STATE OF NORTH CAROLINA
DEPARTMENT OF TRANSPORTATION

Subject: Notification of design change for the replacement of Bridge 311 over Lake Wheeler on SR 1379 (Penny Rd.), Wake County, Division 5, WBS 33351.1.1, Federal Aid Project No. BRZ-1379 (1), State Project No. 8.2408101, T.I.P. No. B-3917.

Revised 08-26-08
 Buried Drawing Sheet 9 of 10

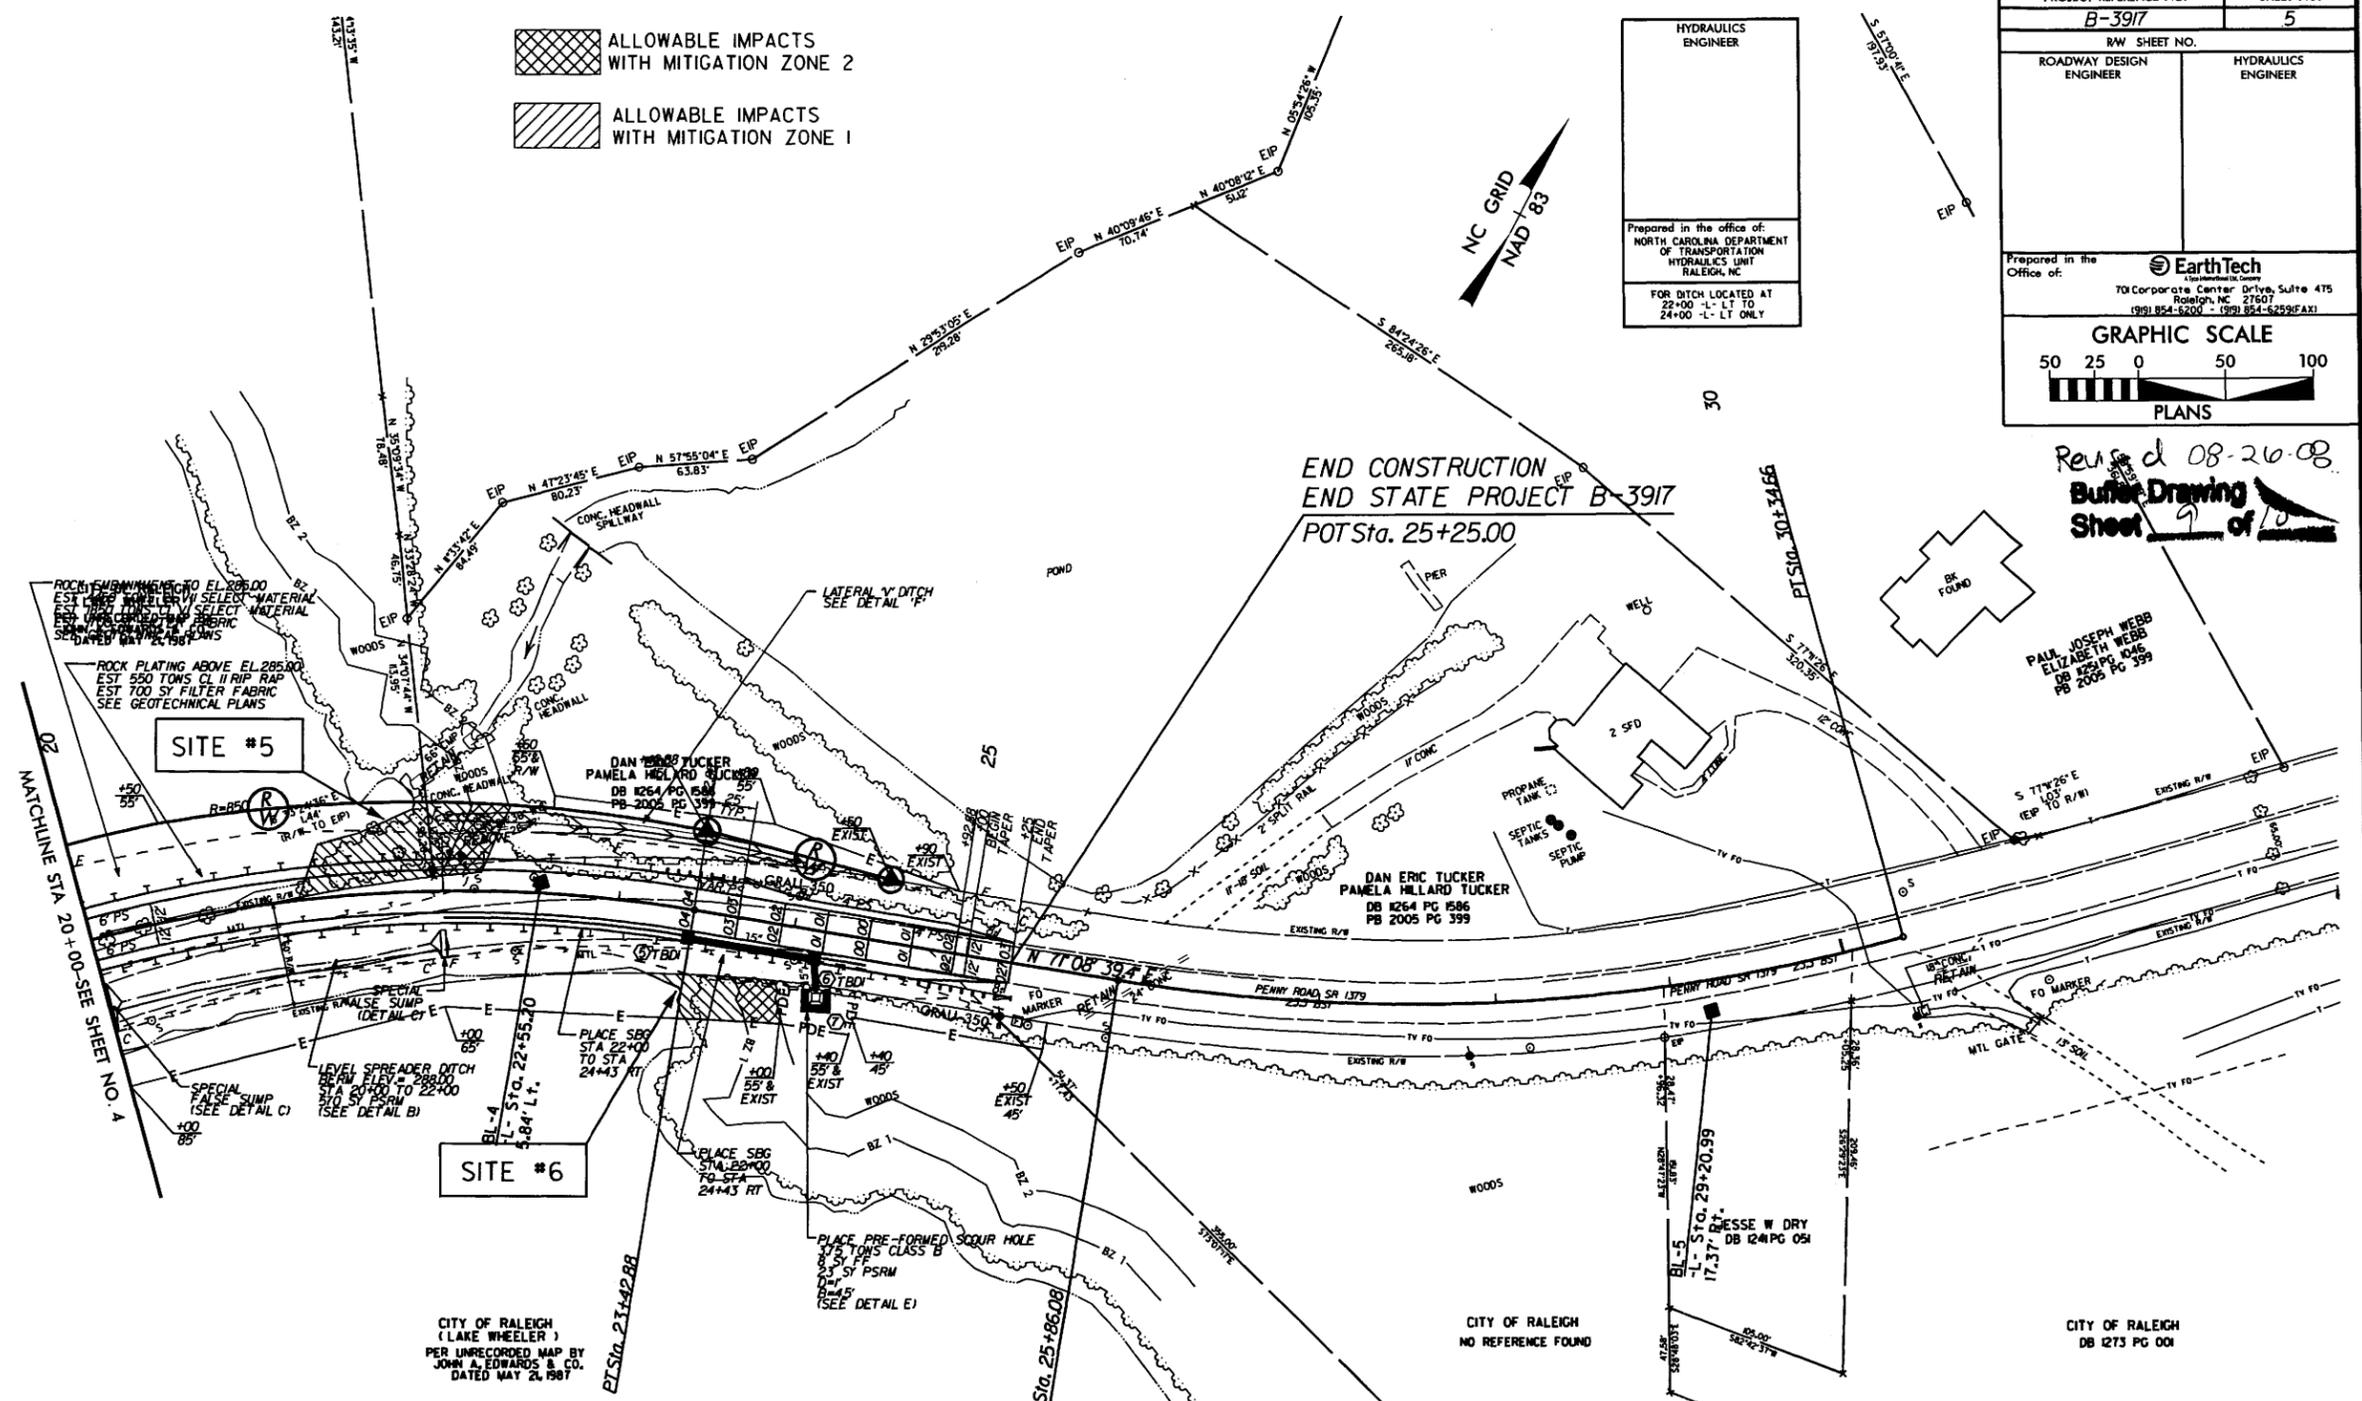
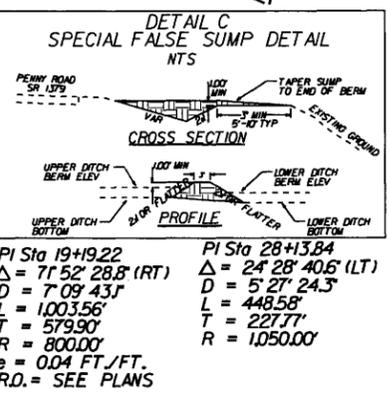
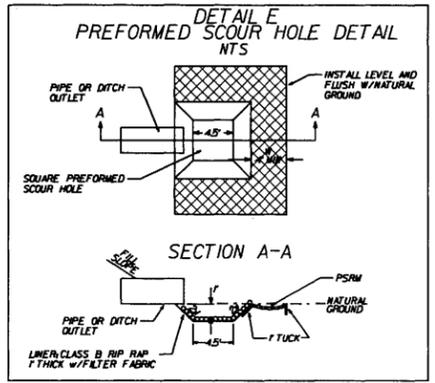
On July 8, 2008 North Carolina Division of Water Quality (NCDWQ) representative Rob Ridings met with North Carolina Department of Transportation (NCDOT) representatives Dan Duffield and Erica McLamb to discuss the ponding of water east of Site 5 (Design Plan Sheet 5, Buffer Permit Drawing Sheet 9 of 10). During this meeting it was determined that the water was not draining because a roadside ditch had been covered during the construction. Dan Duffield proposed reestablishing the ditch in its previous location to allow the water to drain. Rob Ridings agreed that reestablishing the ditch in its pre-existing location was allowable under the Neuse Riparian Buffer Regulations as long as non-erosive velocity was maintained. The reestablished ditch will meet the Neuse Riparian Buffer requirements for treatment and non-erosive velocity.

The buffer impacts were permitted to the easement of the project and this activity would occur within the permitted portion of the project area, therefore no additional impacts would be incurred (see attached Revised Buffer Permit Drawing Sheet 9 of 10 and Design Plan Sheet 5). Rob Ridings determined that the reestablishment of the preexisting ditch would not require a permit modification, but requested a letter of notification to NCDWQ with the revised permit drawings and plan sheets. There will be no additional impacts to jurisdictional streams or wetlands as a result of this activity.

FOR DITCH LOCATED AT
 22+00 -L- LT TO
 24+00 -L- LT ONLY
